# **ANP District Headquarters Facilities in Helmand and Kandahar Provinces Have Significant Construction Deficiencies Due to Lack of Oversight and Poor Contractor Performance**

**October 27, 2010**

SIGAR Audit-11-3

**Photo 6: Crumbling Concrete Stairs of Different Heights at Garm Ser Site**

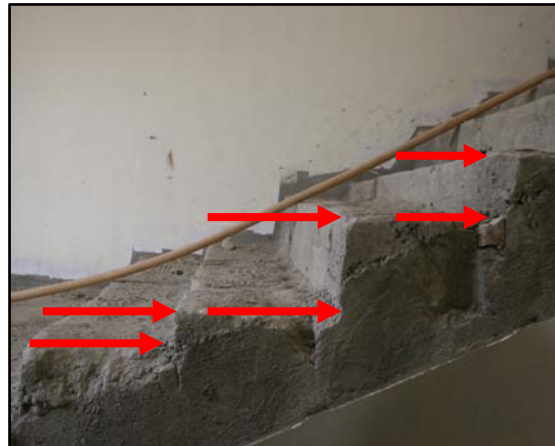
Our inspections found concrete stairs at facilities that were poorly formed, improperly constructed, and comprised of poor concrete with questionable strength. The cast-in-place concrete stairs at all six sites did not conform to the construction drawings either structurally or architecturally. The plans indicated that the stairs were intended to be monolithically cast-in-place reinforced concrete with a curved metal wearing strip embedded at the edge of each step and sealed with a chemical sealant. The treads and risers of the stairs we observed were of varying dimensions. We also observed that the steps were formed separately from the sloped base of the stairs, creating a weakened section that could fail under normal use. Photographs 5 and 6 shows poorly consolidated concrete and improperly formed stairs at Garm Ser.
